Application No.: 10/783,292

Docket No.: SPINE 3.0-448 CONT

REMARKS

FIG. 5A 8A

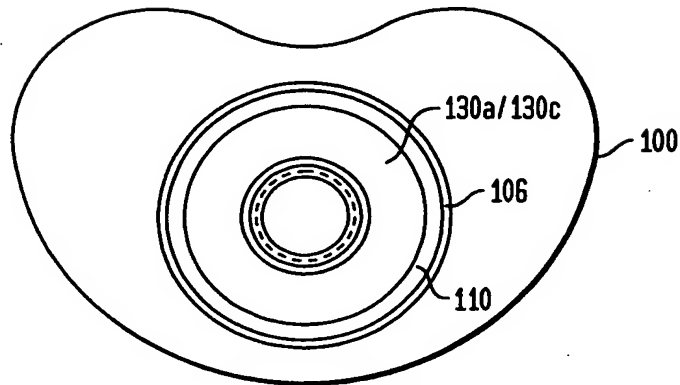
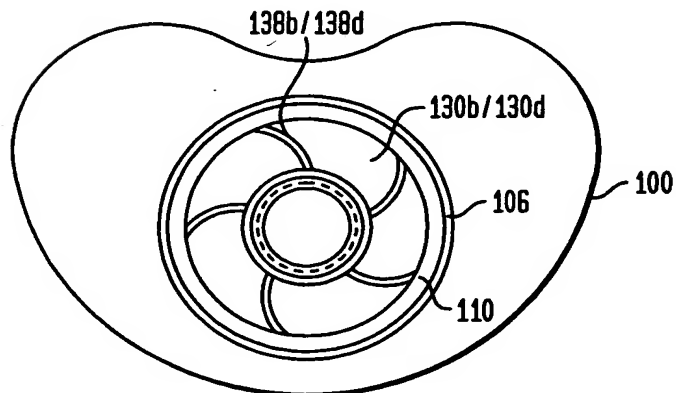
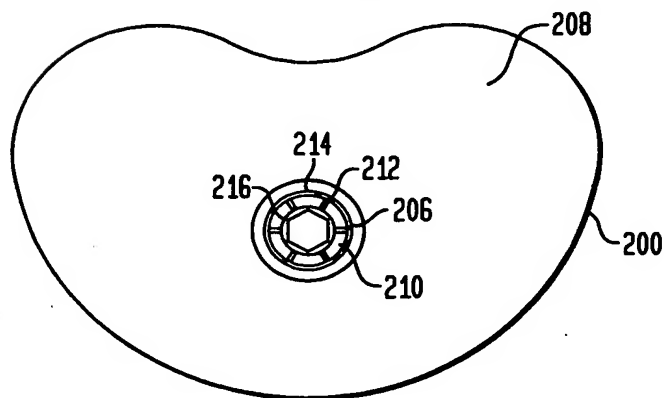
In the Office Action, the Examiner objected to the use of reference characters "138b" and "138d" to designate both radial slots and spiral slots. In response, Applicants have amended FIGS. 5 and 7 as indicated in the attach Letter to the Official Draftsmen.

FIG. 6A 9

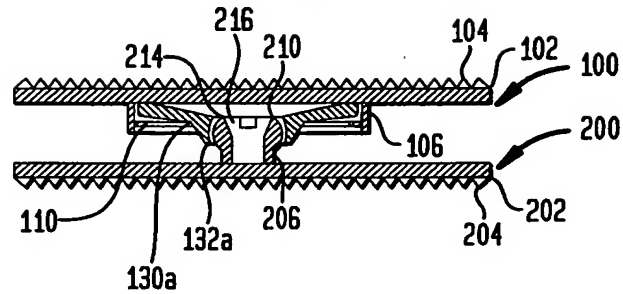
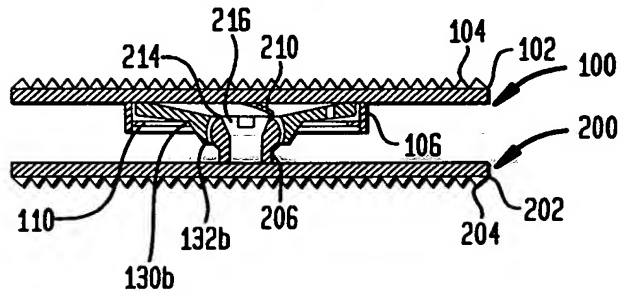
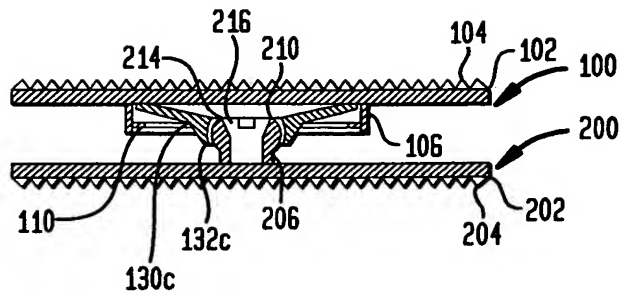
In the present amendment, Applicants have added new claims 6-10, which are fully supported by the originally filed specification and add no new matter. Support for the limitations found in new claims 6-10 are found in drawing FIGS. 9-12 and the specification at paragraphs 30-38.
